SUBJECT: ISSUANCE OF AMENDMENT NO. 75 TO FACILITY OPERATING LICENSE  
NO. NPF-29 - GRAND GULF NUCLEAR STATION, UNIT 1, REGARDING REACTOR  
COOLANT SYSTEM PRESSURE AND TEMPERATURE LIMITS (TAC NO. 76831)

Amendment No. 75  
License No. NPF-29

ATTACHMENT TO LICENSE AMENDMENT NO. 75

SAFETY EVALUATION BY THE OFFICE OF NUCLEAR REACTOR REGULATION  
RELATED TO AMENDMENT NO. 75 TO FACILITY OPERATING LICENSE NO. NPF-29  
ENERGY OPERATIONS, INC.  
GRAND GULF NUCLEAR STATION, UNIT 1  
DOCKET NO. 50-416

FIGURE 3.4.6.1-1

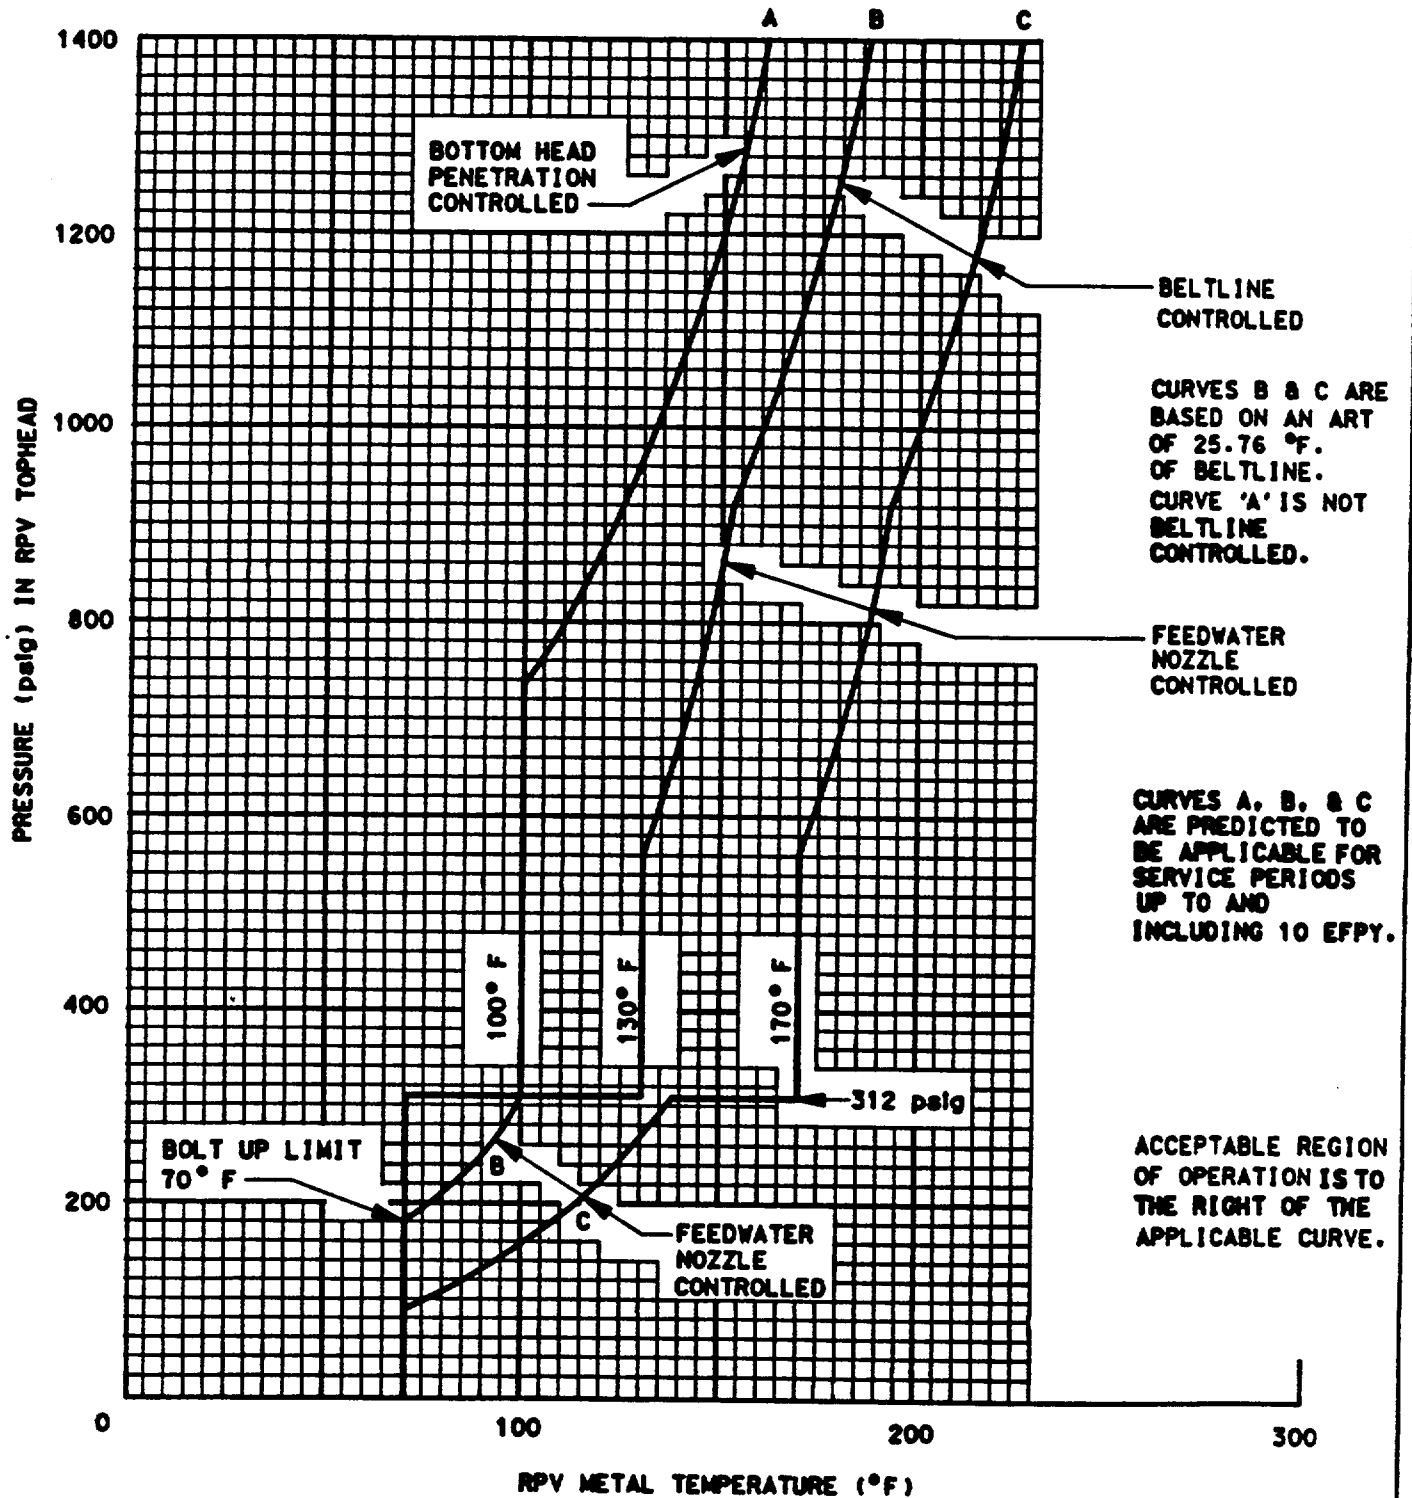
The amendment changes the Technical Specifications (TS) by revising Figure 3.4.6.1-1 "Minimum Reactor Pressure Vessel Metal Temperature vs. Reactor Vessel Pressure" and associated TS Bases and Surveillance Requirements to reflect the revised methodology of Regulatory Guide 1.99, Revision 2, and revised neutron fluence values for the reactor vessel wall. The revised neutron fluence values were based on an analysis of flux wire dosimeters removed from the reactor during the first refueling outage. The revised pressure/temperature (P/T) limits are applicable for service periods up to 10 effective full power years (EFPY) instead of the presently specified 32 EFPY. You are requested to submit a proposed license amendment providing P/T limits for operation beyond 10 EFPY at least 1 year prior to the time the amendment is required to allow appropriate scheduling of the staff review.

The proposed amendment would change the TS by revising Figure 3.4.6.1-1 "Minimum Reactor Pressure Vessel Metal Temperature vs. Reactor Vessel Pressure" and associated TS Bases and Surveillance Requirements to reflect the revised methodology of Regulatory Guide 1.99, Revision 2, and revised neutron fluence values for the reactor vessel wall. The revised neutron fluence values were based on an analysis of flux wire dosimeters removed from the reactor during the first refueling outage. The revised pressure/temperature (P/T) limits are applicable for service periods up to 10 effective full power years (EFPY) instead of the presently specified 32 EFPY.

The staff evaluated the effect of neutron irradiation embrittlement on each beltline material in the Grand Gulf reactor vessel. The amount of irradiation embrittlement was calculated in accordance with RG 1.99, Rev. 2. The staff has determined that the material with the highest adjusted reference temperature (ART) at 10 EFPY at  $\frac{1}{4}T$  ( $T$  = reactor vessel beltline thickness) was the longitudinal weld 627260 with 0.06% copper (Cu), 1.08% nickel (Ni), and an initial reference temperature ( $RT_{NDT}$ ) of  $-30^\circ\text{F}$ . The material with the highest ART at 10 EFPY at  $\frac{3}{4}T$  was plate C2594-2 with 0.04% Cu, 0.63% Ni, and an initial  $RT_{NDT}$  of  $0^\circ\text{F}$ .

The licensee has not removed any surveillance capsules from the Grand Gulf reactor vessel; however, a flux wire dosimeter was removed during the first refueling outage and used to recalculate neutron fluence (Section 2.1). For the limiting beltline material at  $\frac{1}{4}T$ , longitudinal weld 627260, the staff calculated the ART to be  $25.2^\circ\text{F}$  at 10 EFPY. For the limiting beltline material at  $\frac{3}{4}T$ , longitudinal plate C2594-2, the staff calculated the ART to be  $11.2^\circ\text{F}$  at 10 EFPY. Based on the licensee revised neutron fluence of  $2.1 \times 10^{18}$  n/cm<sup>2</sup> at end of life, the staff calculated a fluence of  $6.5 \times 10^{17}$  n/cm<sup>2</sup> at  $\frac{1}{4}T$  and  $2.9 \times 10^{17}$  n/cm<sup>2</sup> at  $\frac{3}{4}T$  for the 10 EFPY P/T limits.

The licensee used the method in RG 1.99, Rev. 2, to calculate an ART of 25.76°F at 10 EFPY at 1/4T for the same limiting weld metal. Substituting the staff calculated ART of 25.2°F into equations in SRP 5.3.2, the staff verified that the proposed P/T limits for heatup, cooldown, and hydrotest meet the beltline material requirements in Appendix G of 10 CFR Part 50 except that the cooldown temperature at 1000 psi is about 14°F lower (less conservative) than the staff's calculated temperature. The staff judges that a difference of 14°F in the high pressure region of the P/T limits is acceptable in this particular case because at the lower pressure region of the cooldown limit curve, the licensee's temperatures are conservative.

4.4.6.1.5 The pressure-temperature limit curves in Figure 3.4.6.1-1 are valid through 10 effective full power years (EFPY) and shall be re-evaluated prior to exceeding 10EFPY.

The staff concludes that the proposed P/T limits for the reactor coolant system for heatup, cooldown, leak test, and criticality are valid through 10 EFPY because the limits conform to the requirements of Appendices G and H of 10 CFR Part 50. The limits also satisfy Generic Letter 88-11 because the licensee used the method in RG 1.99, Rev. 2 to calculate the ART. Hence, the proposed P/T limits may be incorporated into the Grand Gulf 1 Technical Specifications.

BASES FIGURE B 3/4.4.6.1 FAST NEUTRON FLUENCE (E>1MeV)  
AT VESSEL I.D. AS A FUNCTION OF EFPY.

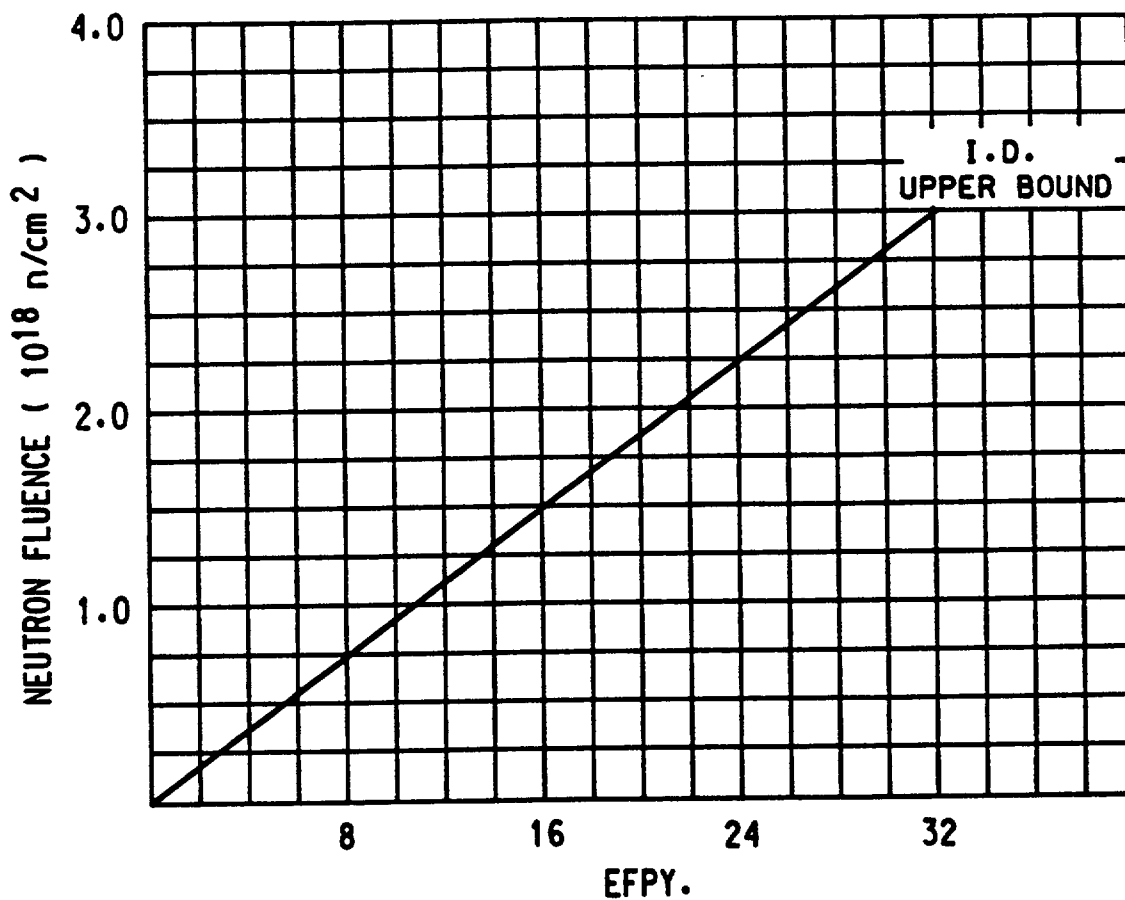
The estimate of the 10.0 EFPY peak azimuthal fluence to the pressure vessel is based on an end of Cycle 1 flux wire measurement from a flux wire dosimeter attached to the surveillance capsule at 3° on the azimuthal. The first cycle

lasted for 0.93 EFPYs. The fluence measurement was based on the measured decay rate of the reaction  $\text{Fe-54}(n,p)\text{Mn-54}$ . This is the most common reaction for this type of measurement. The Mn-54 half life is 312.2 days and is therefore suitable for a one cycle irradiation. However, the actual irradiation time in this instance was about 3 years. The analysis accounted for the measurement uncertainties which were estimated at  $\pm 25\%$  (2 sigma). The modeling of the flux attenuation was based on the two-dimensional DOT neutron transport code in (R,0) geometry. One-eighth core geometry was used with 26 energy groups,  $P_3$  angular scattering expansion and  $S_8$  quadrature approximation. This calculation was primarily used for the estimation of the azimuthal flux distribution required to translate the  $3^\circ$  wire flux measurement to the peak flux at  $45^\circ$ . The 0.93 EFPYs of the first cycle fluence was then scaled to 10 and 32 EFPYs at the clad-vessel interface. Finally, the method suggested in Regulatory Guide (RG) 1.99, Rev. 2, was used to estimate the corresponding values at  $\frac{1}{4}T$ , i.e. one quarter thickness of the pressure vessel.

We have reviewed the information submitted by letter dated November 30, 1990, regarding the determination of the pressure vessel fluence at the peak azimuthal location  $\frac{1}{4}T$  thickness at 10 EFPYs, required for the determination of the P/T limit curves. We find the measurement of the flux to be acceptable, because it used the standard reaction for similar determinations and has a reasonable uncertainty associated with it. The translation of that measurement was made with the DOT code using acceptable approximations. The estimation of the  $\frac{1}{4}T$  thickness fluence from the inner diameter value was performed using the RG 1.99, Rev. 2 method. Finally, the value proposed was the upper limit rather than the nominal estimate which is very conservative. Therefore, we find the proposed fluence of  $2.1 \times 10^{18}$  n/cm<sup>2</sup> end-of-life at  $\frac{1}{4}T$ , peak azimuthal location with E greater than 1.0 MeV, acceptable.
